# Determination 2024/048

**Regarding an authority's decision to grant a building consent**

**12 Beach Road, Haumoana, Hawke's Bay**

This determination considers an authority's decision to grant a building consent regarding building work associated with the relocation of an existing dwelling. The authority believes it granted the building consent in error, and that decision should be reversed, due to concerns that have subsequently arisen with the designs for the on-site surface water and foul water disposal systems.

**Figure 1. Site plan (not to scale)<sup>9</sup>**

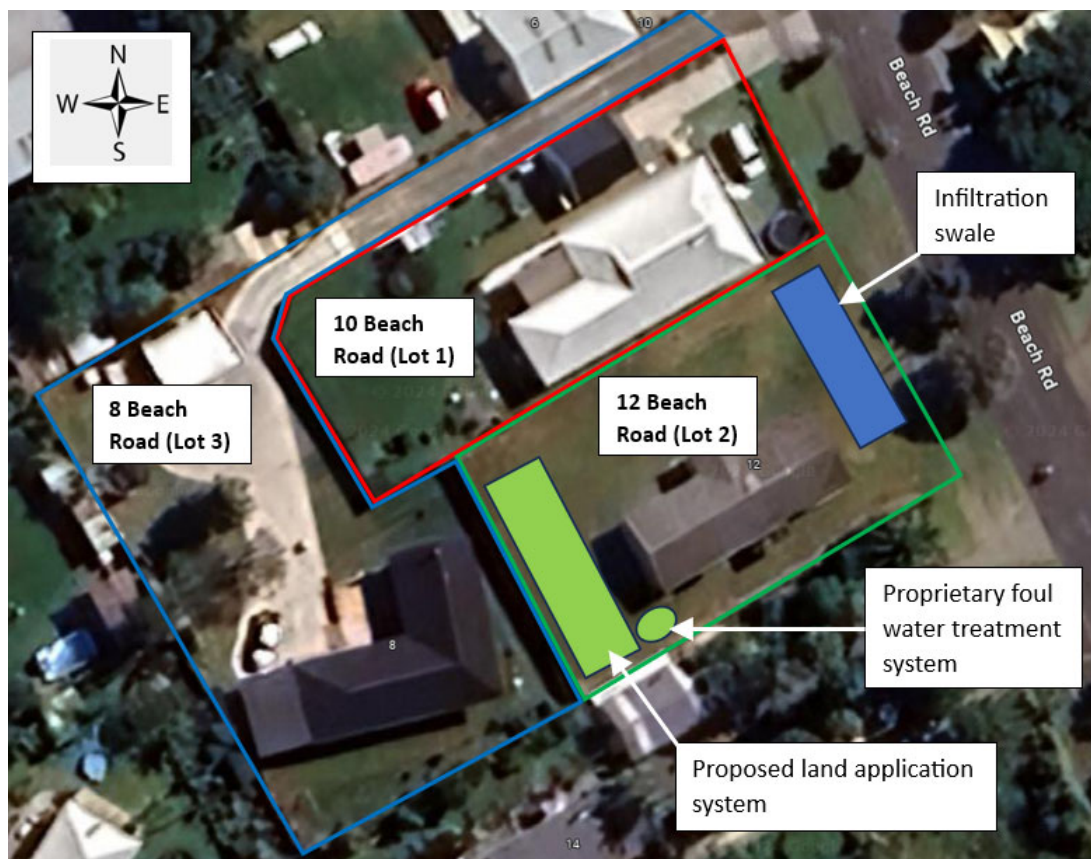
5.17. However, the same checklist also states, “Effluent disposal system is outside of [the] flood zone, therefore the natural hazard won’t affect [the] effluent system”. I agree. The authority’s maps indicate the extent of the flood hazard is to the east side of the property, whereas the in-ground AWTS and land application system is proposed to be sited to the west side of the property (refer to paragraph 2.3.2 and figure 1).
